Re: **Insignificant Permit Modification**
Gibson Station RWS I Landfill, FP 26-06
Gibson Generating Station
Owensville, Indiana

Duke Energy Indiana, LLC (DEI) respectfully submits to the Indiana Department of Environmental Management the attached Insignificant Permit Modification for the Gibson South Landfill RWS Type I FP #26-06.

Re: Insignificant Permit Modification Request
Modification to Approved Landfill West Expansion Limits
Gibson Station South RWS I Landfill (RWS I Landfill)
SW Program ID 26-06
Gibson County, Owensville, Indiana 47665
Atlas Project No. 170DUK0034

FIGURE 1

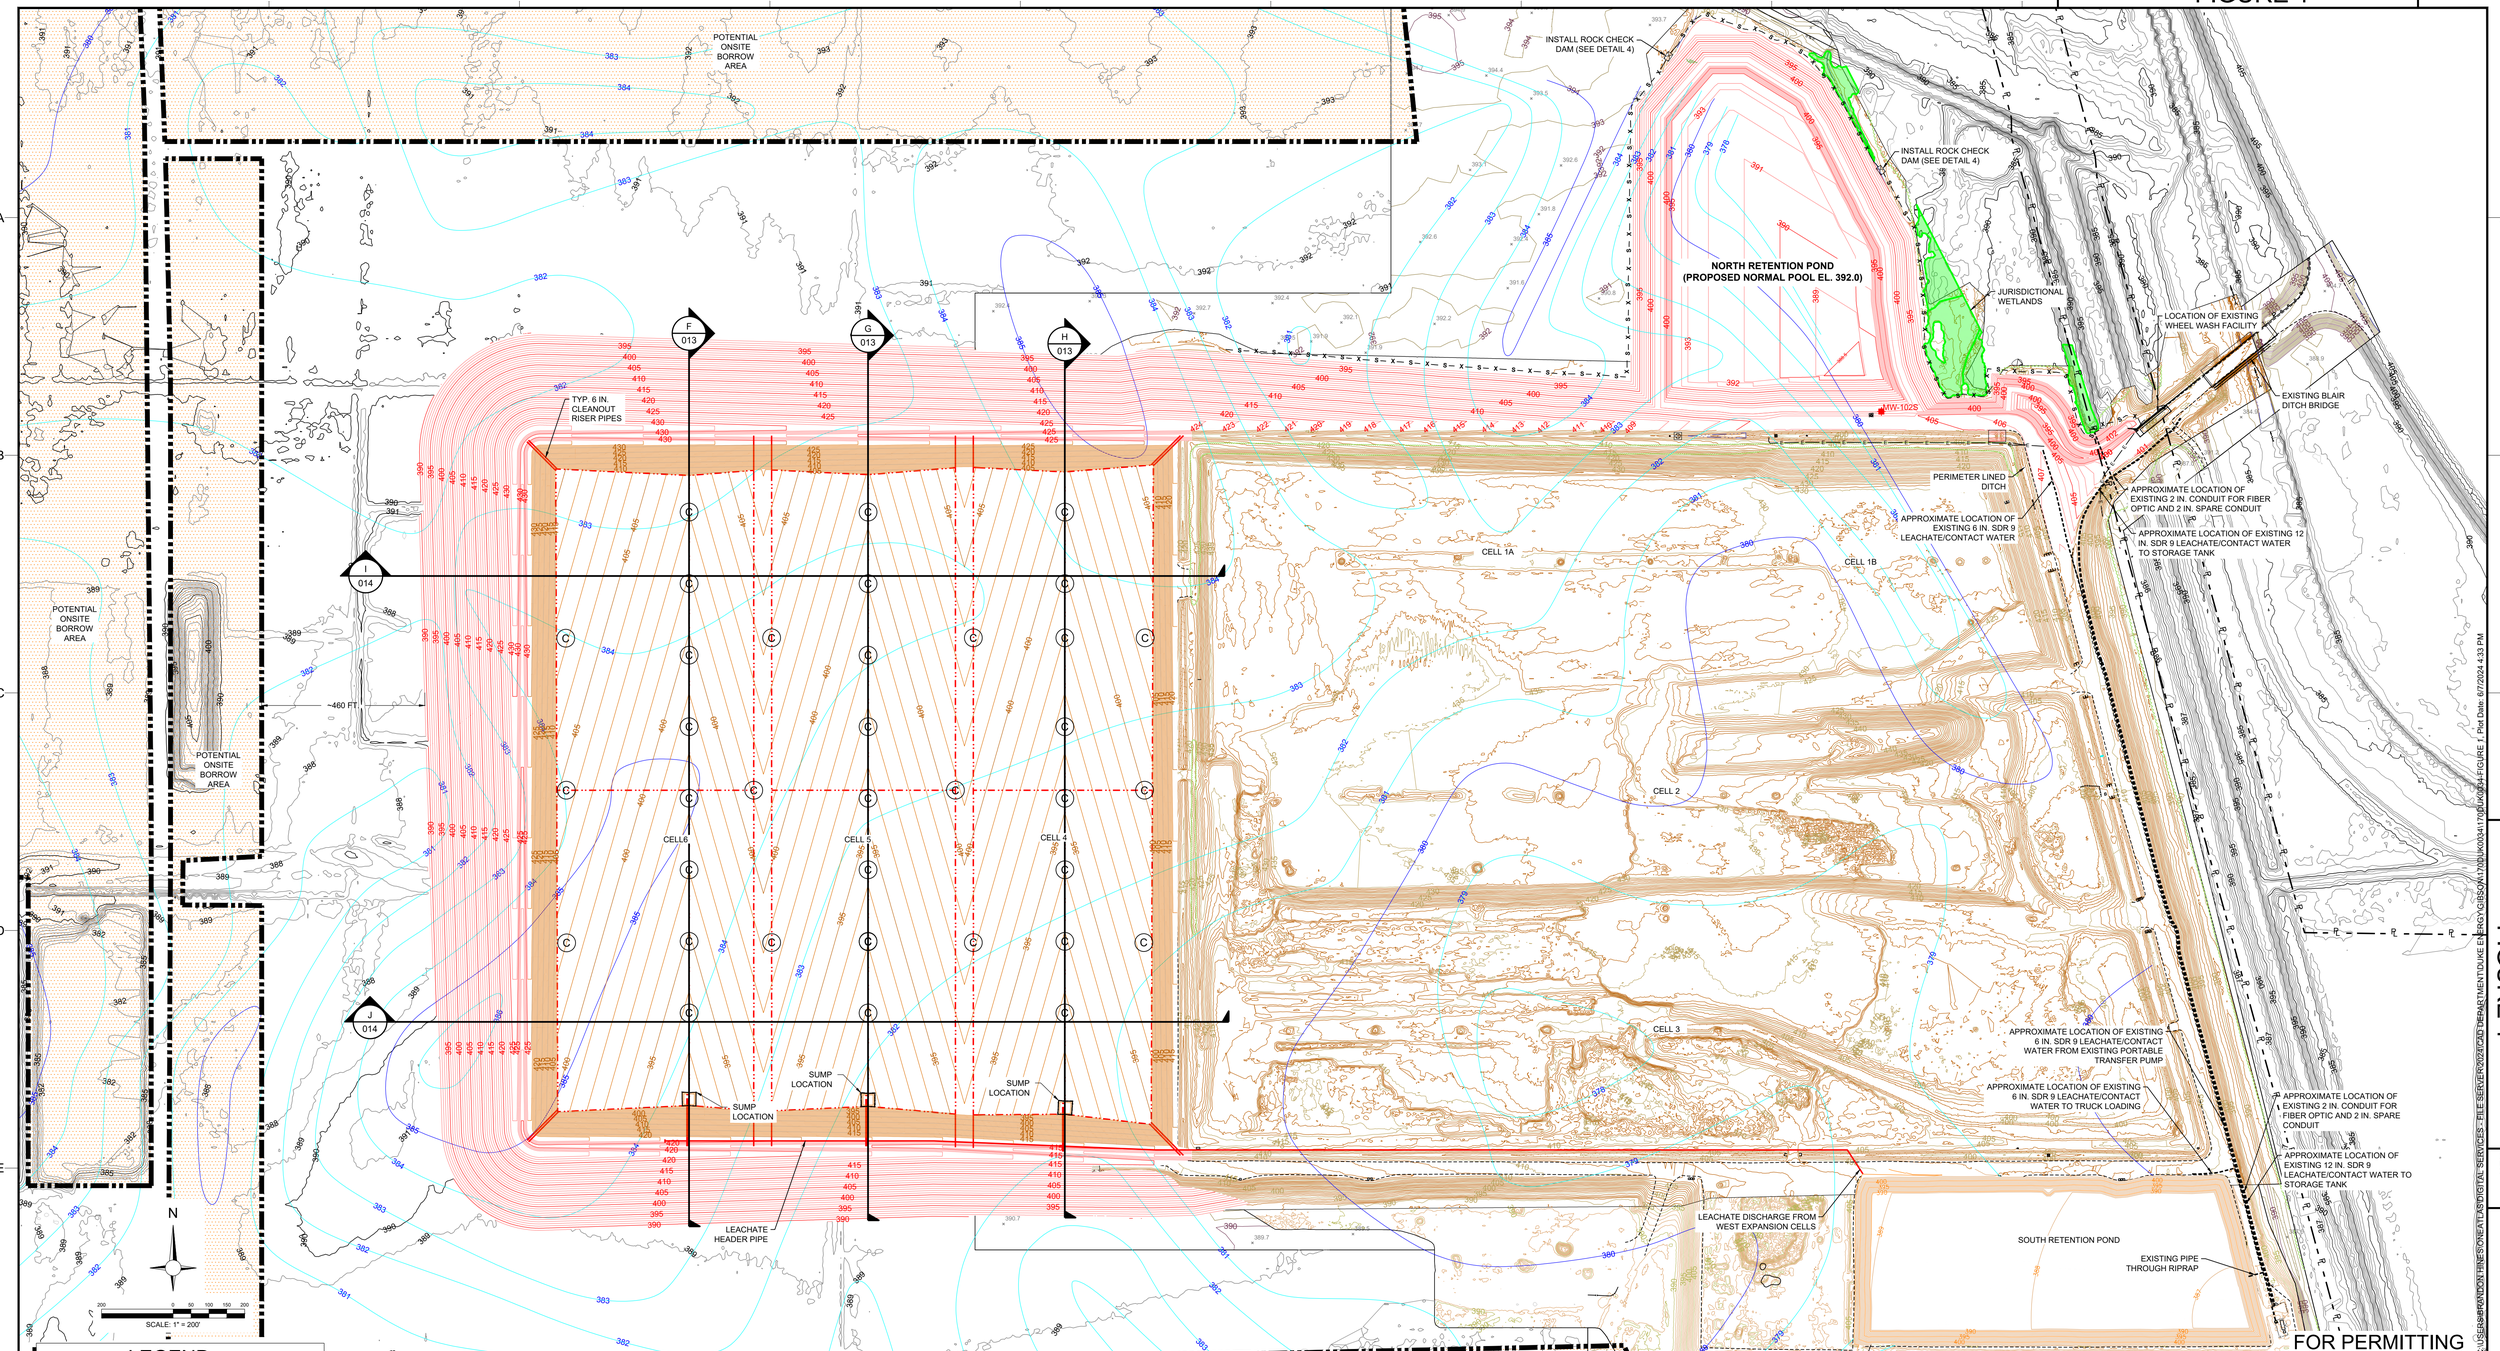
The RWS I Landfill received its operating permit on November 29, 2005. Currently, Cells 1, 2, and 3 have been constructed and are operational. In 2020, Duke Energy engaged Atlas Technical Consultants (Atlas) to evaluate the projected coal combustion residuals (CCR) waste to be generated from the Gibson Station based on station retirement in 2038 and the required airspace in the RWS I Landfill for the disposal of the projected CCR waste. Based on that evaluation, it was determined that a horizontal expansion of approximately 80 acres was needed. A minor modification request was subsequently submitted to IDEM in 2021 for a horizontal expansion of the landfill to construct three additional cells (4, 5, and 6), each roughly 27 acres, on the west side of existing Cells 1, 2, and 3. Following discussions and revisions, the minor modification request (VFC #83263150) was approved by IDEM on May 11, 2022. Figure 1, attached, shows the approved west expansion limits for Cells 4, 5, and 6.

FIGURE 2

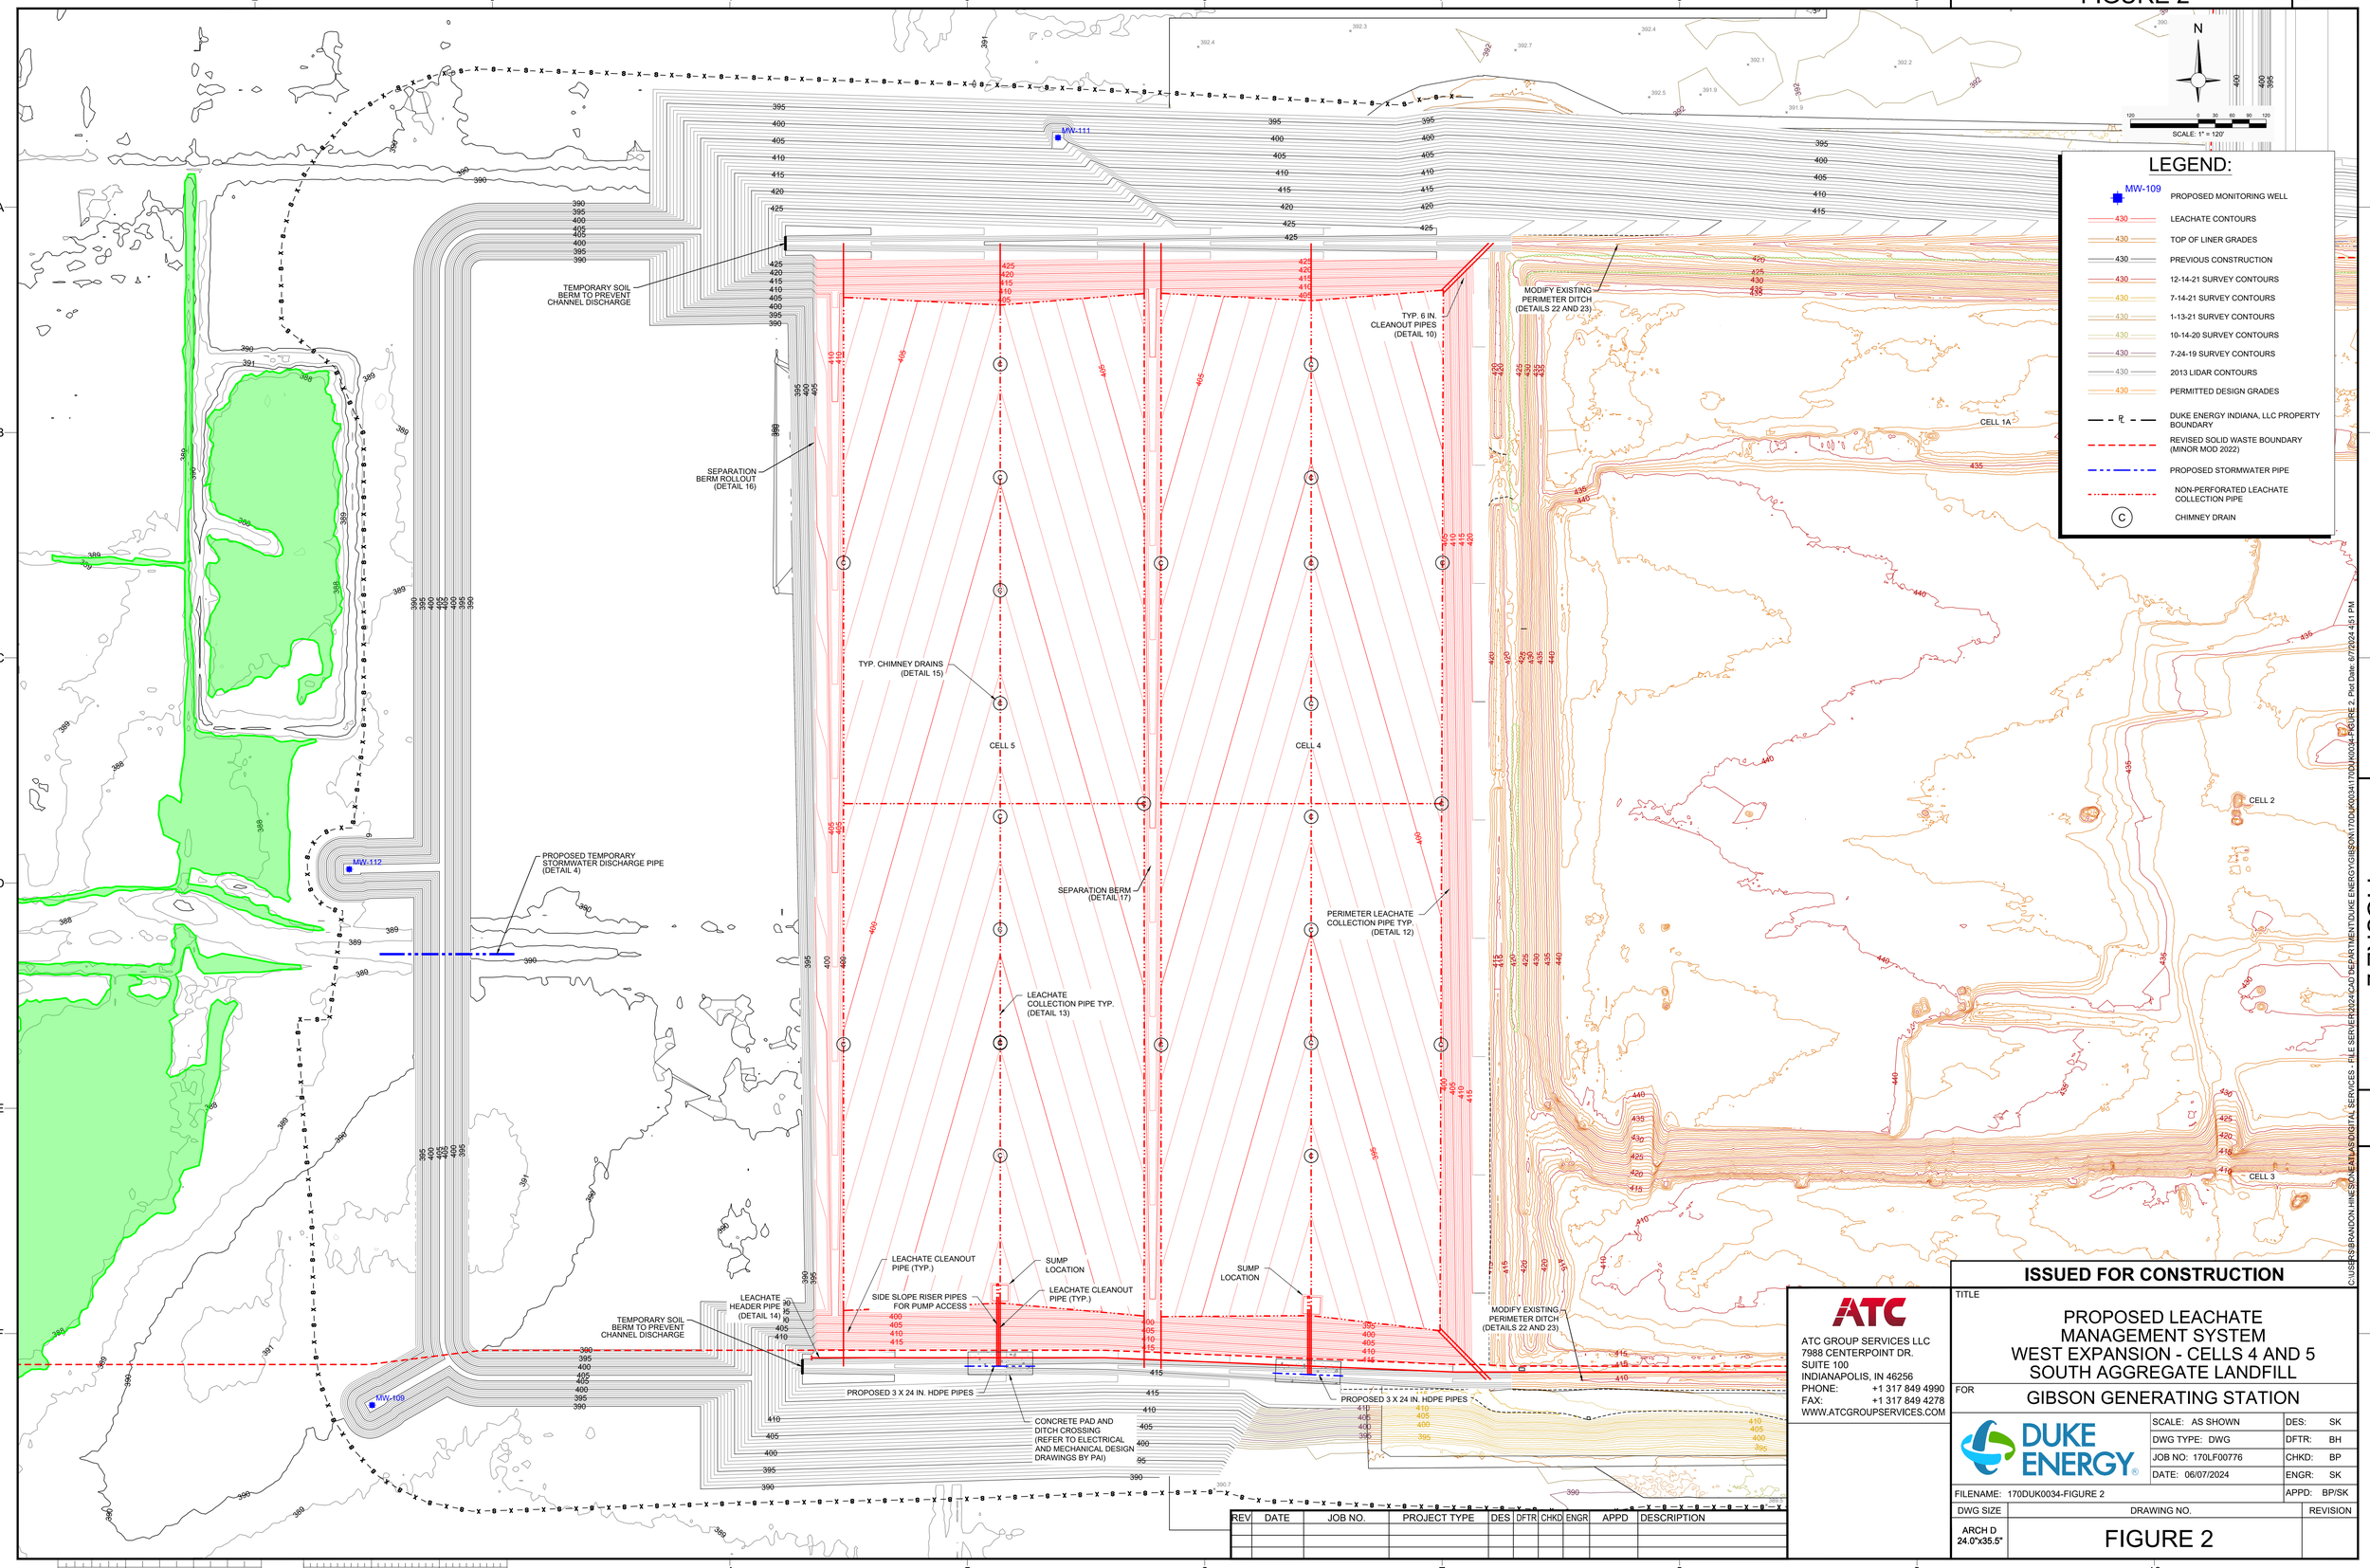
After receiving minor modification approval from IDEM, Duke Energy began planning for the construction of Cells 4 and 5 with a partial perimeter berm, as shown in Figure 2, with plans to construct Cell 6 at a future date. However, in the fall of 2023, Duke Energy updated the decommissioning plan for the Gibson Plant, resulting in a significant reduction in the projected CCR waste generation. At Duke Energy's request, Atlas reviewed the available airspace in Cells 1, 2, and 3 and re-evaluated the additional airspace required. Based on this evaluation, Atlas determined that constructing only Cell 4 will sufficiently accommodate the projected CCR waste from the Gibson Plant, making Cells 5 and 6 unnecessary in the near future. Figures 3, 4, 5, and 6, attached, depict the proposed modifications to the landfill expansion limits.
